Product Change Notification / SYST-14KFNM046

ERRATA - PIC16(L)F1782/1783 Family Silicon Errata and Data Sheet Clarification

Description of Change: Updated Table 2; Added sections 6.3 and 6.4; Other minor corrections.

FIGURE 1: ADC 12-BIT MODE, SINGLE-ENDED INL, $V_{DD} = 3.0V$, $T_{AD} = 4 \mu s$, $25^{\circ}C$, TYPICAL MEASURED VALUES

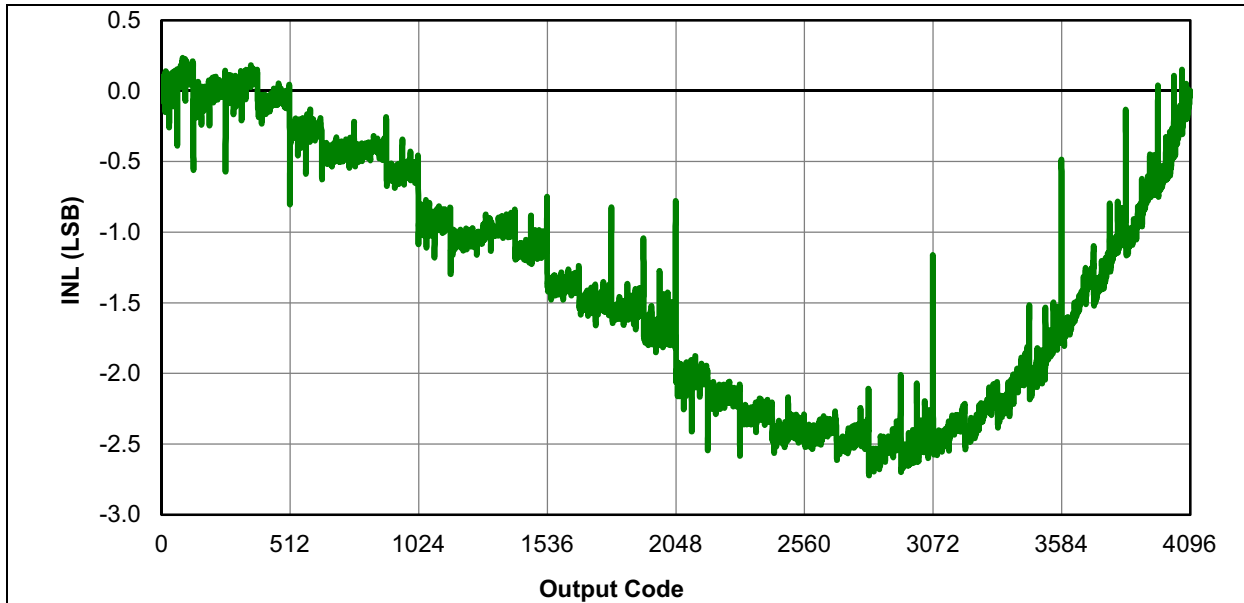
1.3 ADC INL (12-bit mode)

The ADC linearity is ± 4 LSB for the 12-bit mode. Below are typical INL graphs in 12-bit mode (See [Figure 1](#) and [Figure 2](#)).

None.

FIGURE 3: OP AMP TYPICAL OFFSET VOLTAGE AT 25°C, HIGH GBWP MODE (OPAxSP = 1), VDD = 3.6V, 0V ≤ CMV ≤ 5.5V

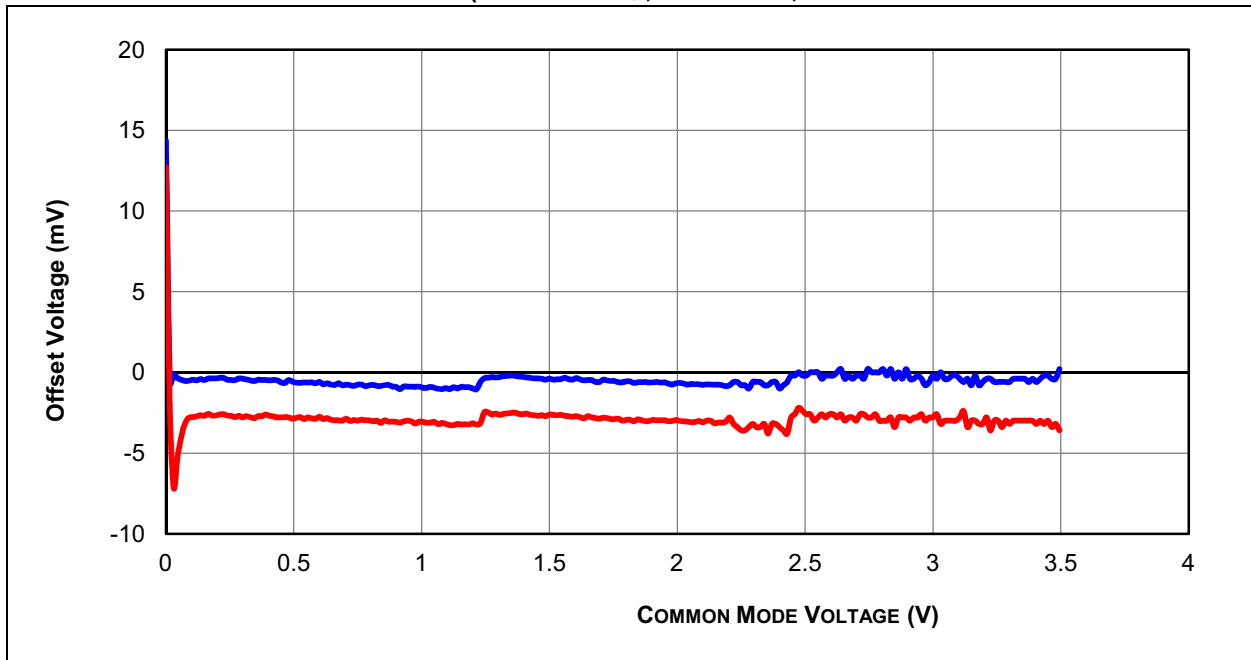
2.1 Offset at Low Common Mode

The op amp offset at Common mode input voltages below 200 mV increases with respect to temperature. Below are typical graphs showing the increase in offset (See [Figure 3](#), [Figure 4](#) and [Figure 5](#)).

None.

FIGURE 6: COMPARATOR INPUT OFFSET, TYPICAL MEASURED VALUES, NORMAL SPEED MODE ($CxSP = 1$), $V_{DD} = 5.5V$, PIC16F1782/1783 ONLY

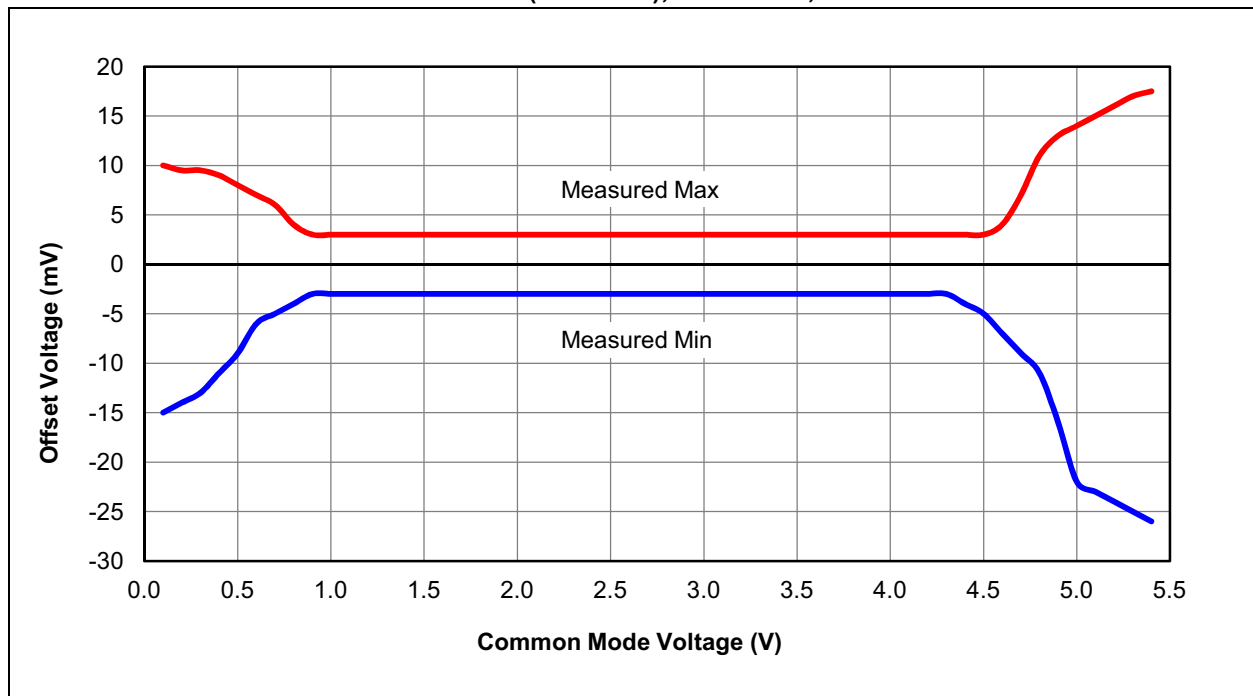
3.2 Typical Offset Performance

CMRR performance for the range of $V_{SS} + 1V$ to $V_{DD} - 1V$ is better than specified in the data sheet.

See [Figure 6](#) and [Figure 7](#).
